UNITED STATES PATENT AND TRADEMARK OFFICE

APPLICATION NO.	FILING DATE	FIRST NAMED INVENTOR	ATTORNEY DOCKET NO.	CONFIRMATION NO.
10/720,278	11/25/2003	Alain Poiraud	2937-115	4789

Office Action Summary

DETAILED ACTION

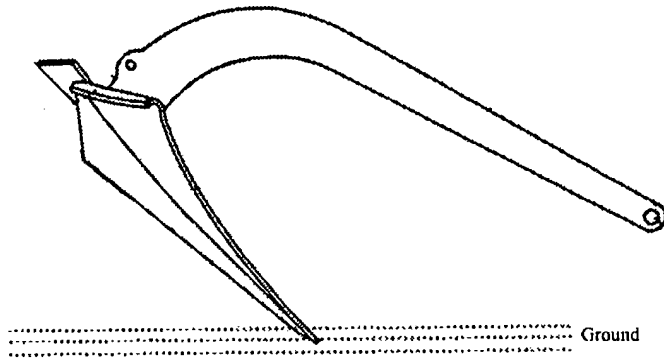
Re claim 1, Goodman shows a boat anchor [10] (figures 1 and 2), having a fluke [15,16] with a tip [17] and a back with a curved rear edge [18], and a shank [11] mounted on the fluke. The shank has a curved edge, and an opening [14] at an end opposite the fluke. The opening is offset from a plane tangent to the back edge of the fluke and to the edge of the shank. When considered in a side elevation view (see fig. 2), the anchor is considered asymmetric with respect to a horizontal plane passing the shank.

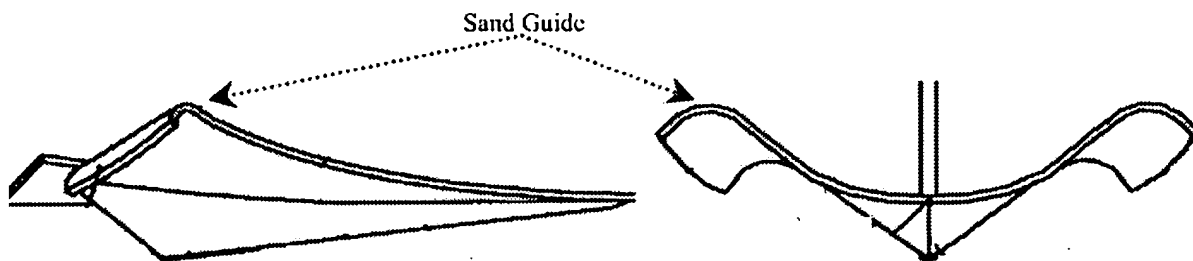
Re claim 5, if the anchor is tipped in an orientation shown below, most of the weight of the anchor will be borne by the tip of the anchor. In such orientation, the proportion of the weight of the anchor on the tip would higher than 20%.

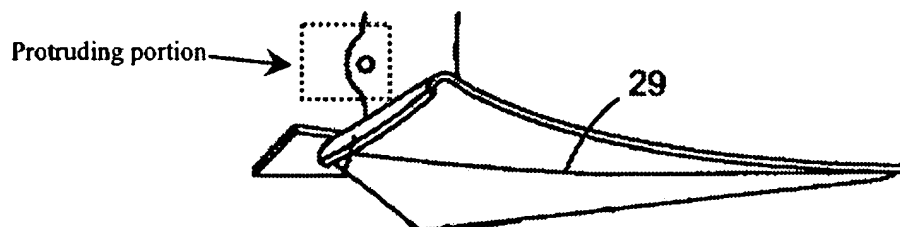
Re claim 9, the sloped upper surface of the back upper side is considered equivalent to a sand guide because when the anchor is dragged through the sand, the sloped surface would allow the sand to be guided over and behind the anchor.

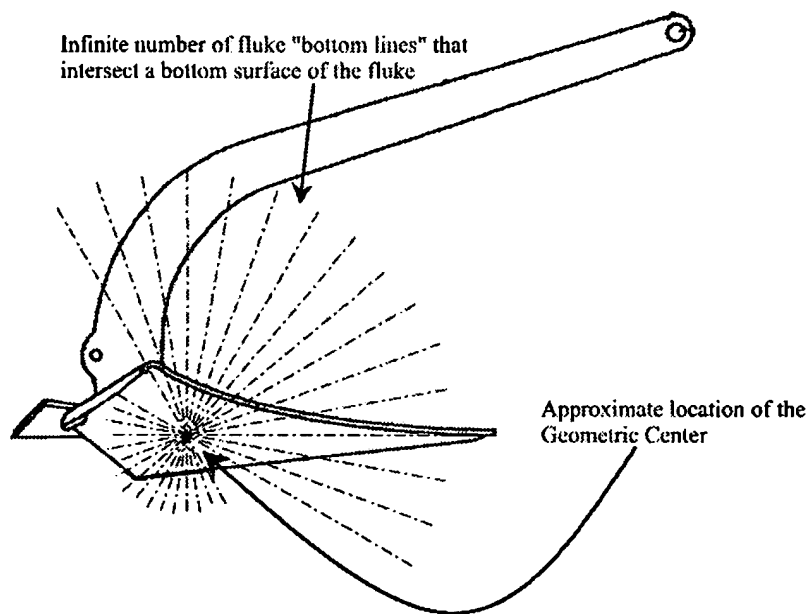
Peabody ('456) shows an anchor having second openings [18B, 18C] in proximity to a first opening [18A] of an arcuate shank (fig. 3). The second openings allow for a variation in the fluke's effective angle of attack, thereby enabling the most effective anchor penetration (fig. 3, and col. 1, lines 8-10, lines 18-24; and col. 2, lines 4-8).

It would have been obvious for one skilled in the art at the time of the invention to provide second openings in the shank of Goodman, as taught by Peabody, such that the second openings were disposed in proximity to the first opening. Having such second openings would have allowed one to vary the fluke's effective angle of attack, thereby allowing the anchor to be used effectively in different types of marine beds.
